PROJECT:	Nebraska State Patrol Crime Lab	PROJECT NO.	#L13459
FROM:	BVH Architects	DATE:	7/11/14
TO:	Bidders	ADDENDUM NO.	#2

ADDENDUM NO. CC-2

Nebraska State Patrol Crime Lab
Lincoln, Nebraska - 2014
OA Project No. 014/A14-0651

Date	07/11/14	VOSS & ASSOCIATES Inc. STRUCTURAL ENGINEERS	
Project Name	Nebraska State Patrol Crime Lab	SHEET	Add. No. 2 S1

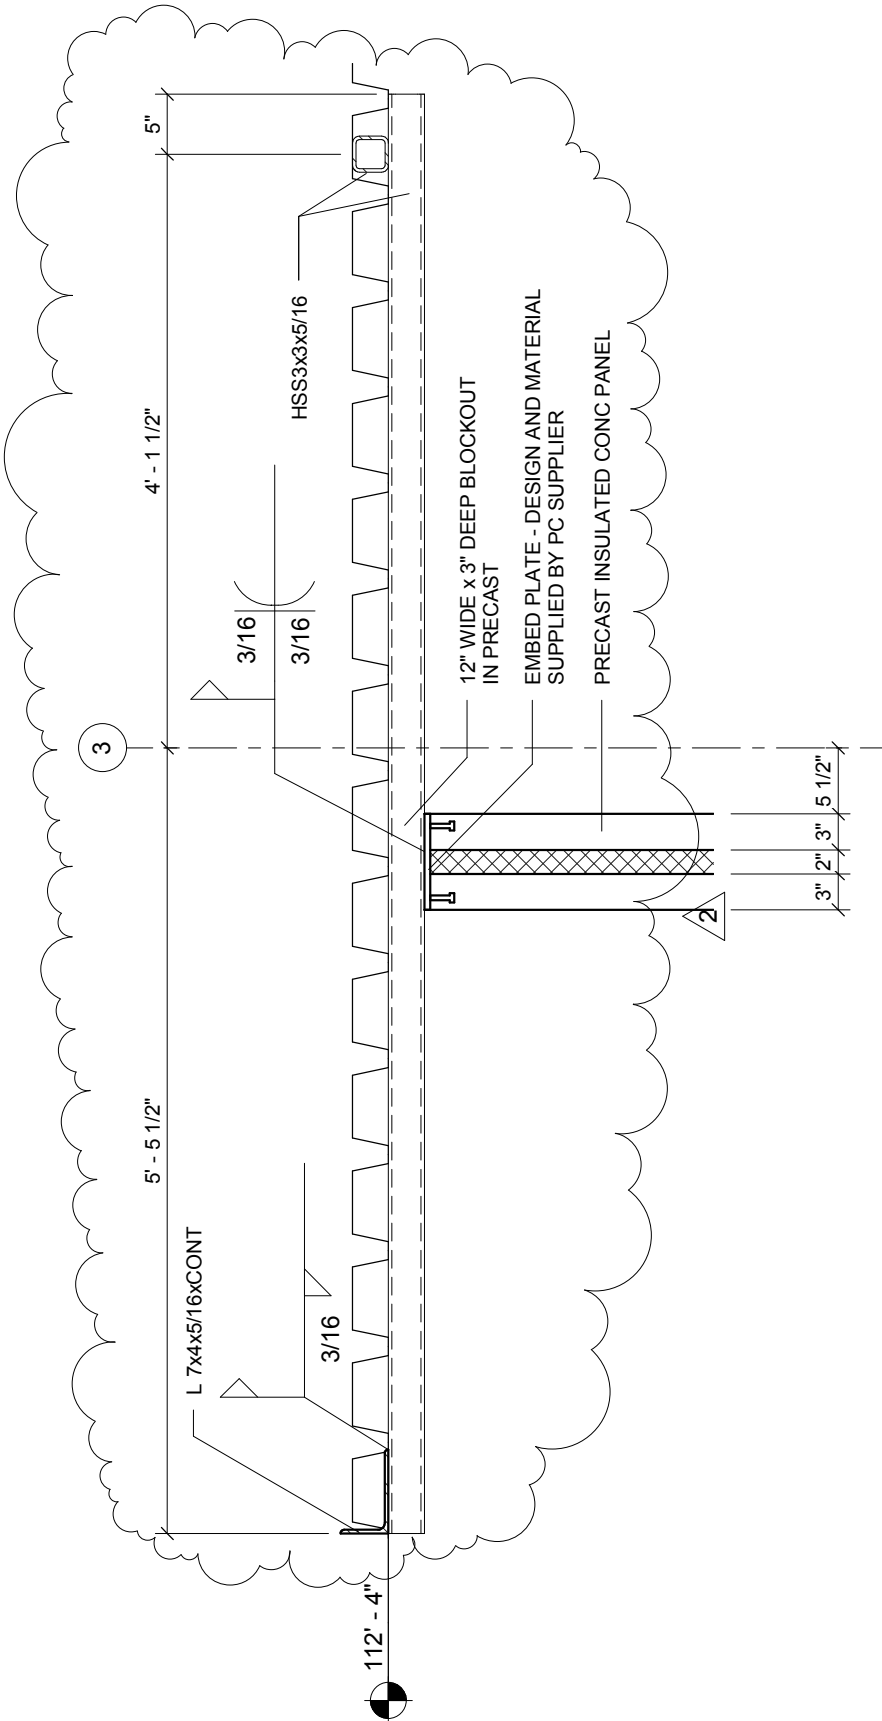
1. ALL PRIMARY BEAM TO PRIMARY BEAM CONNECTIONS SHALL BE DOUBLE ANGLE OR DOUBLE PLATE CONNECTIONS.
2. ALL PRIMARY BEAM TO COLUMN CONNECTIONS SHALL BE SINGLE PLATE CONNECTIONS.

REF. SHEET S1.1-S (STANDARD STEEL CONNECTION SCHEDULE)

Add. No. 2
 S3

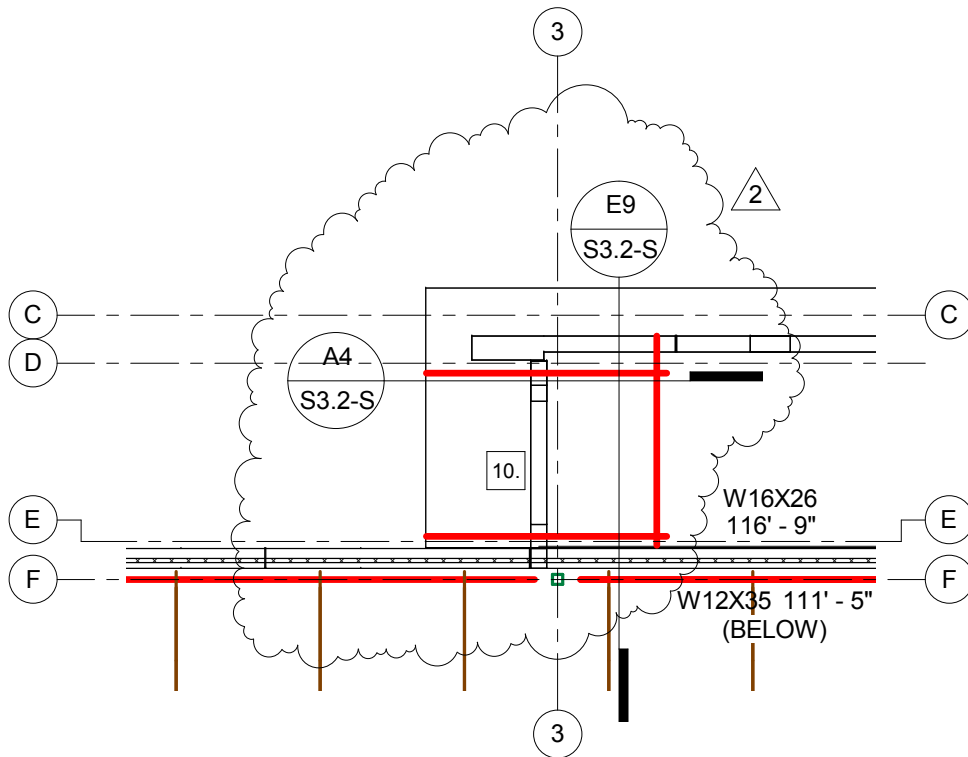
REF. SHEET S3.2-S

**Attachment No. 1
to Addendum No. CC-2
dated July 11, 2014**

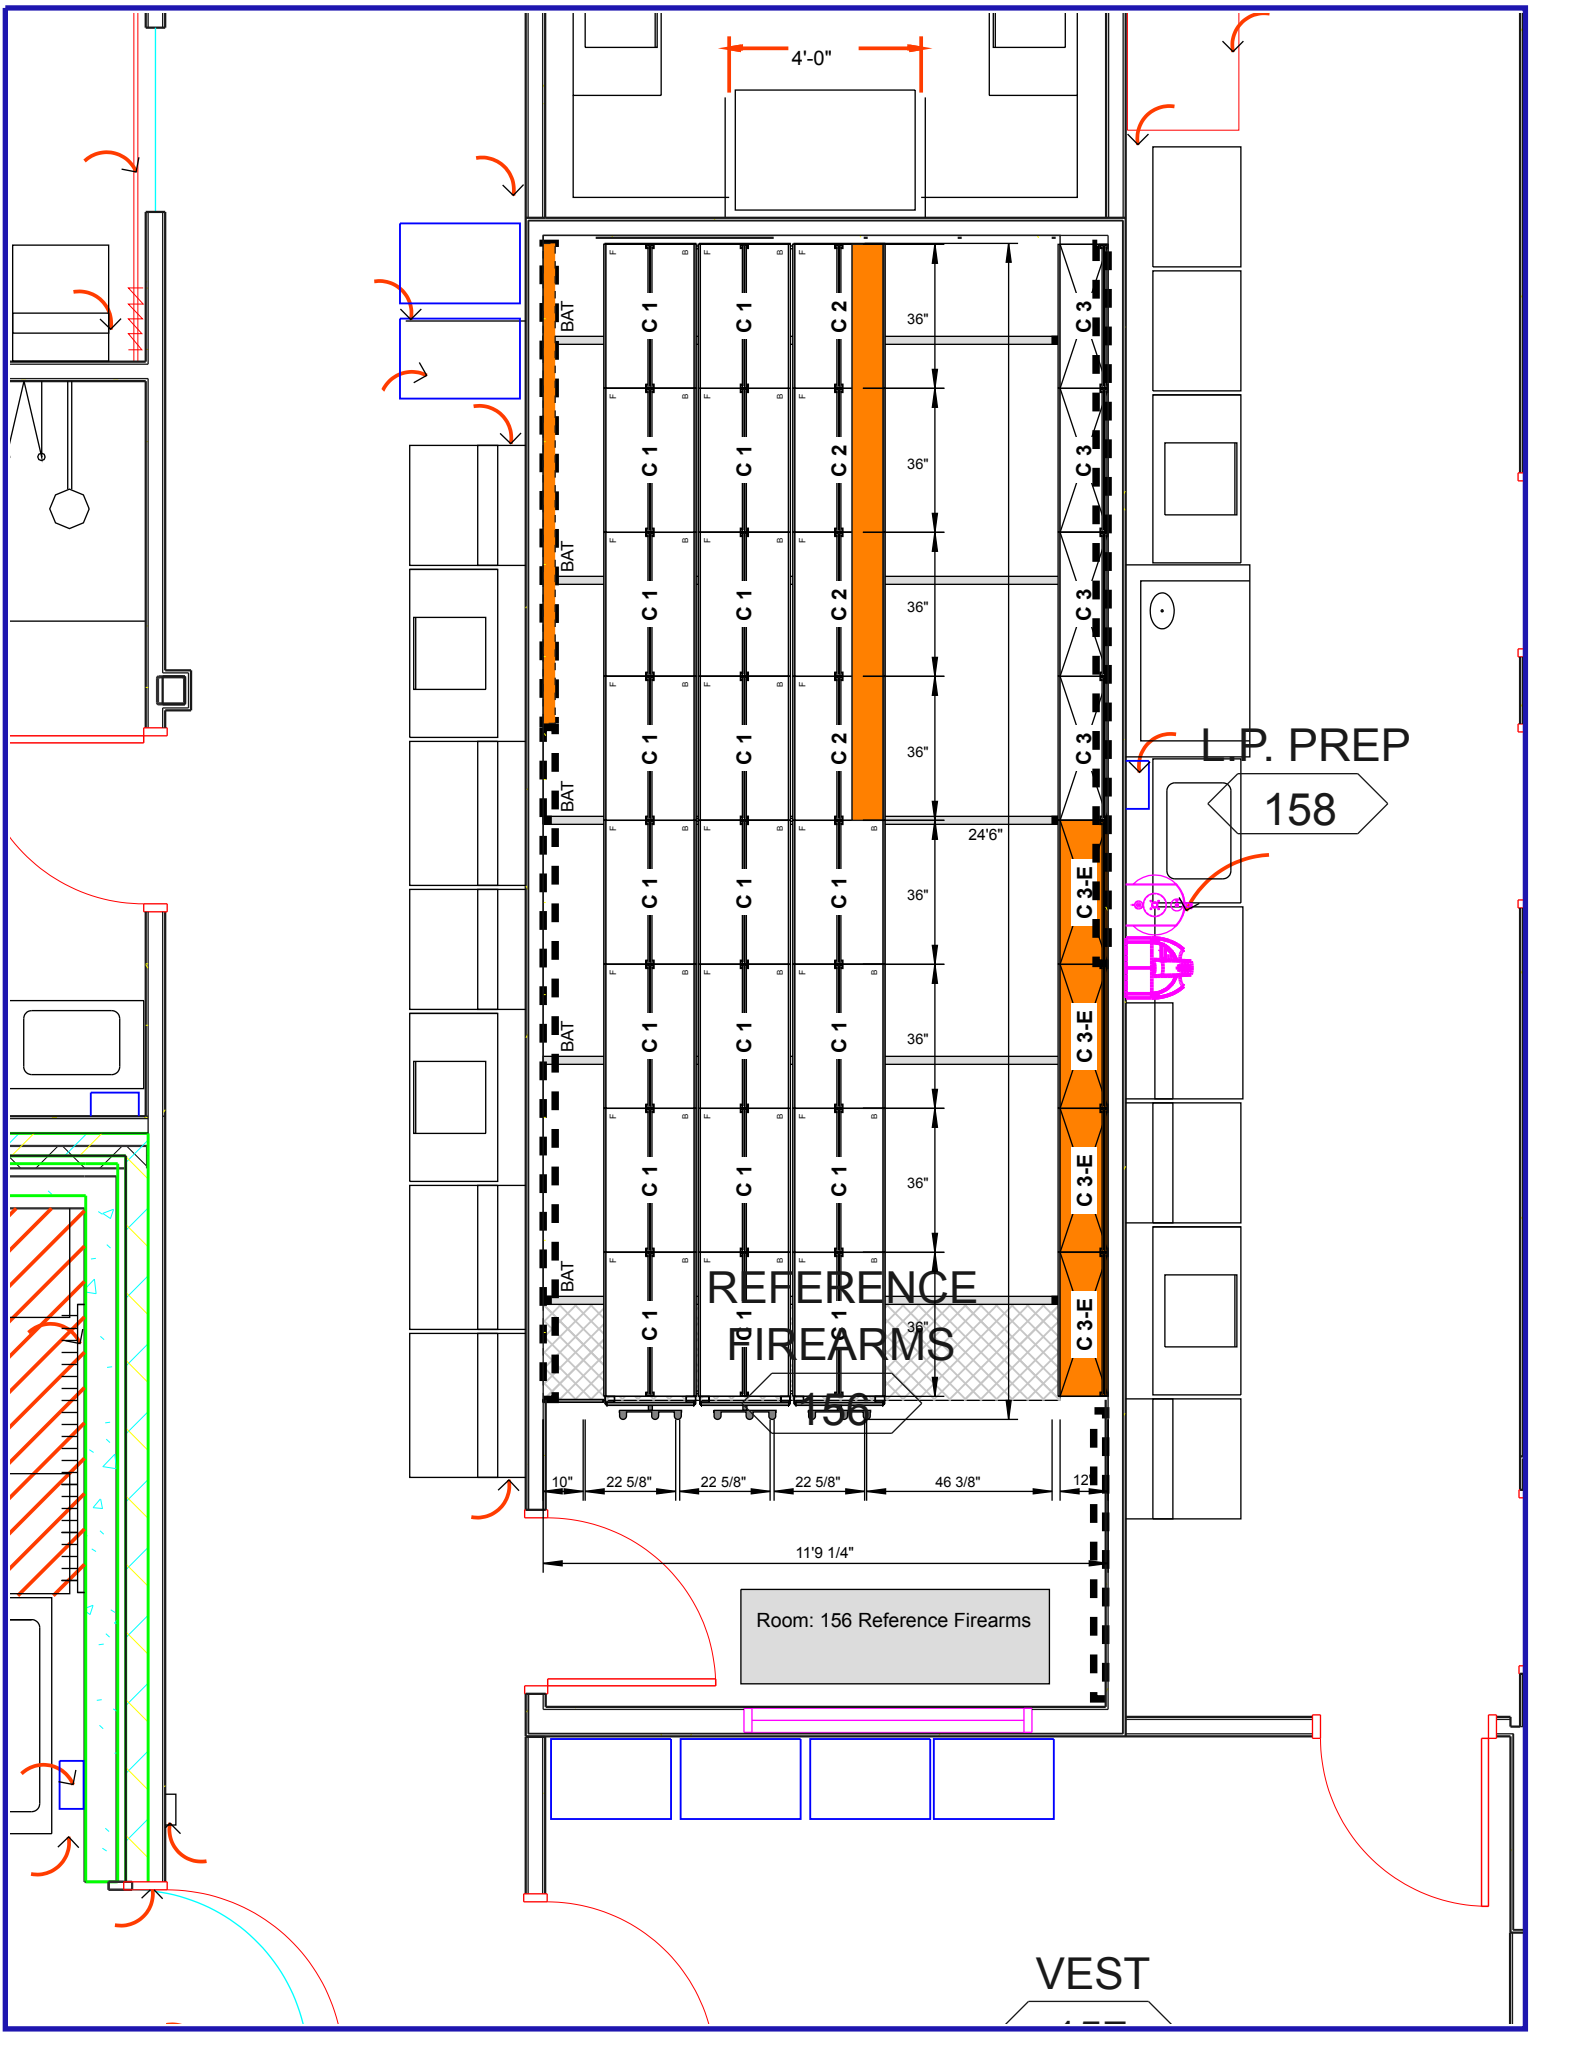
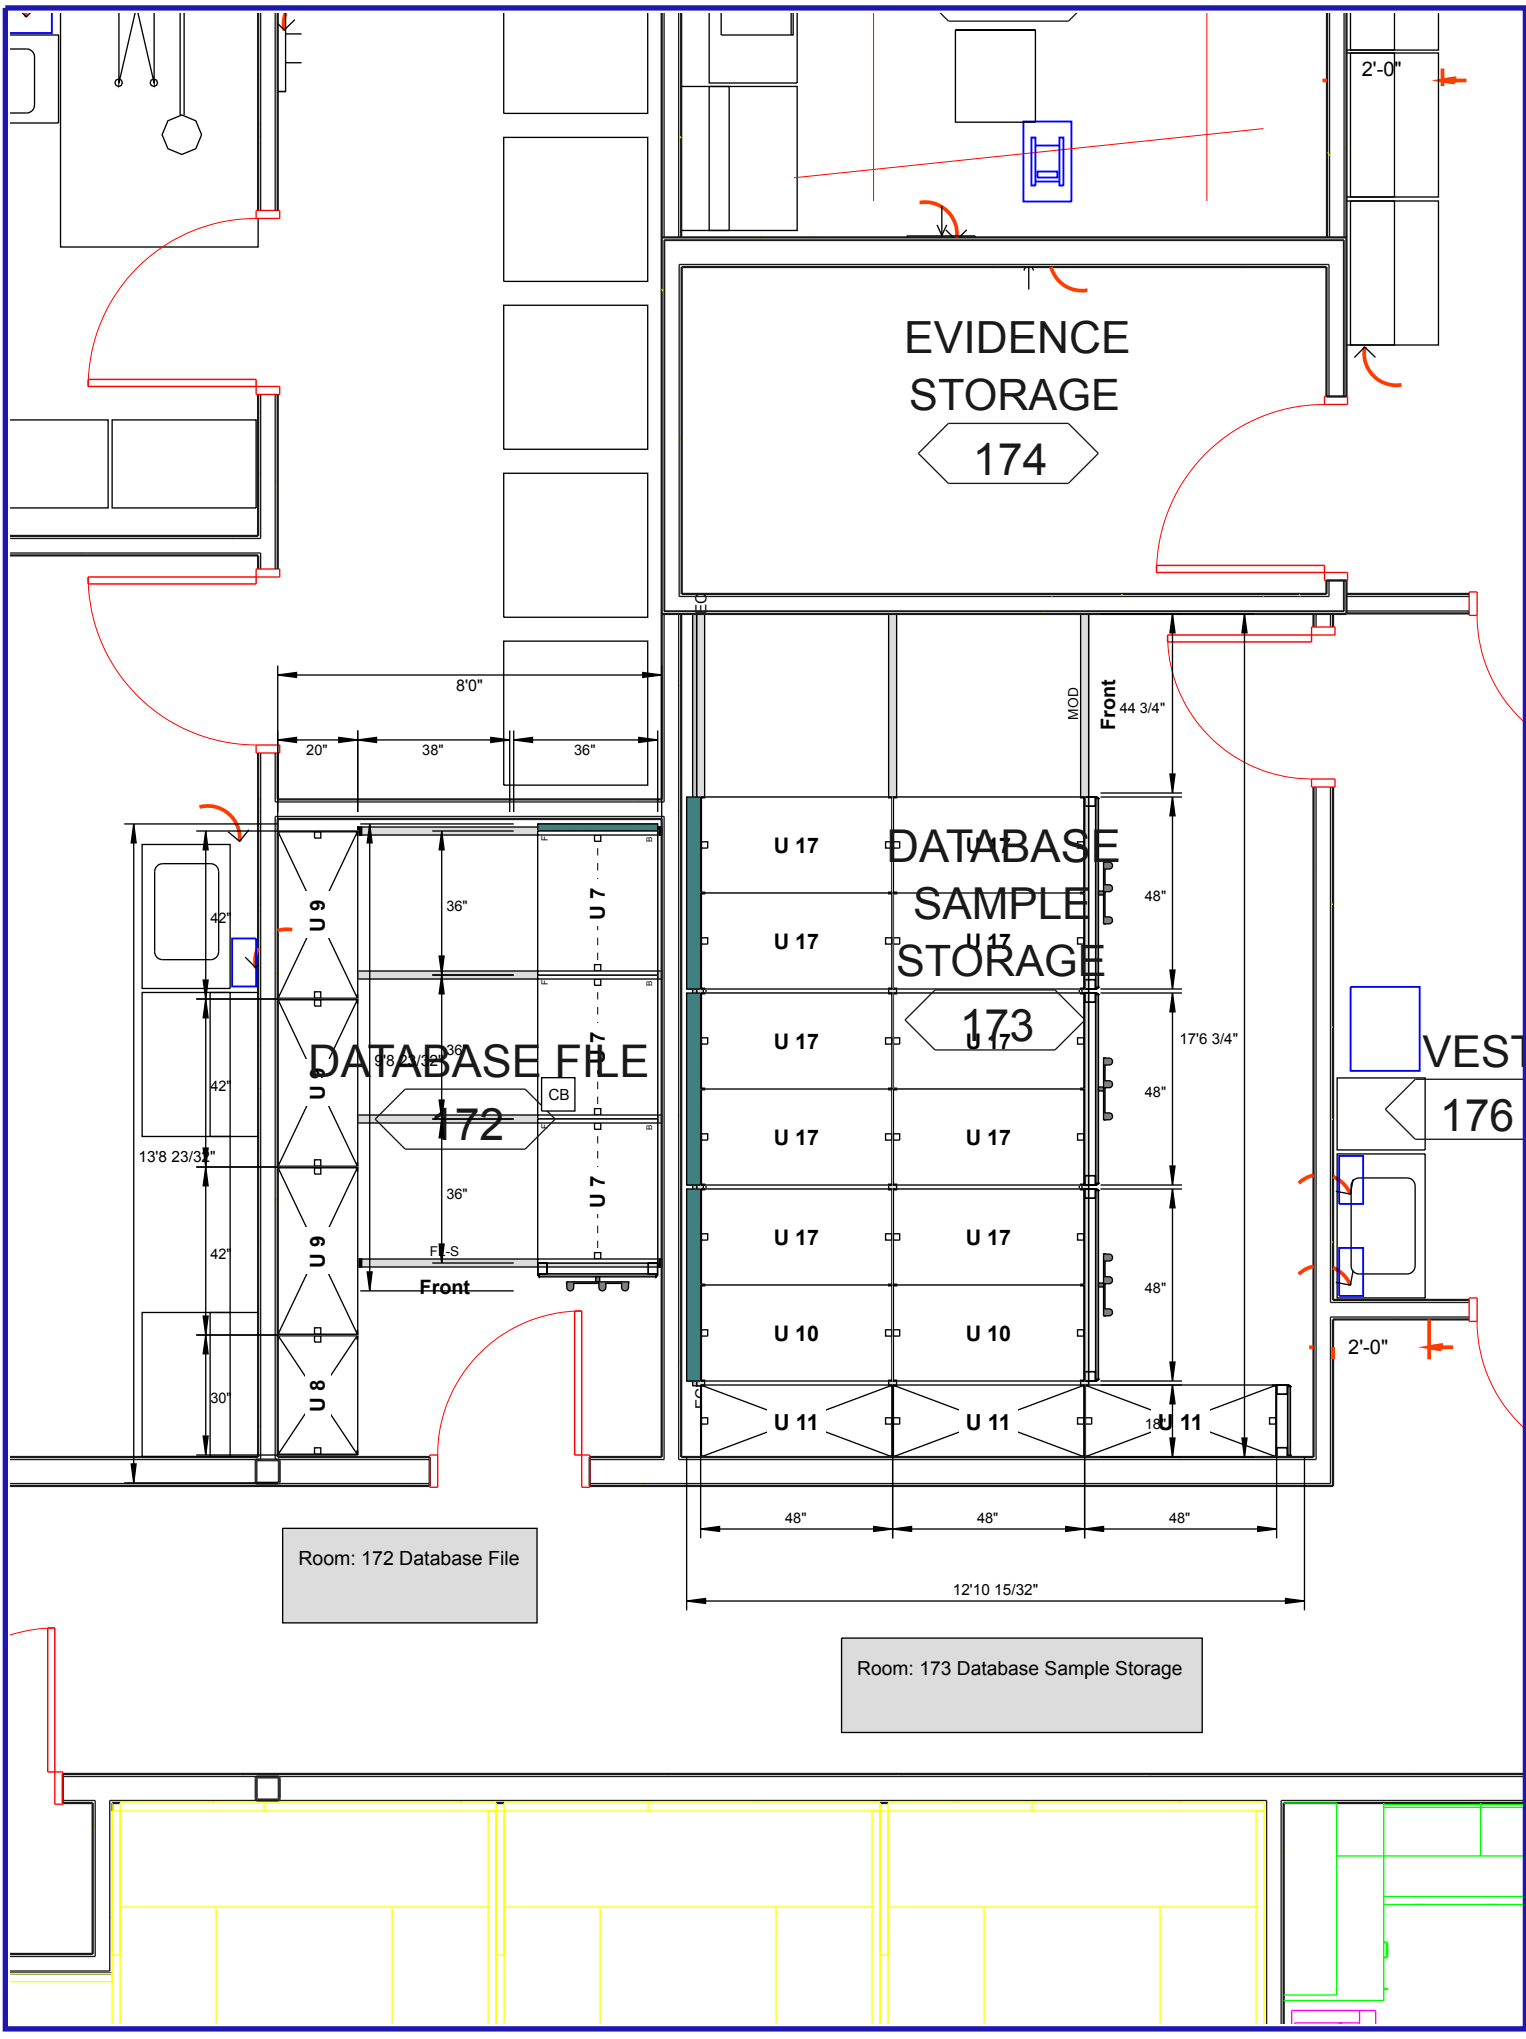
A. Add Detail Sheets to the end of this Section as shown on Attachment No. 1.
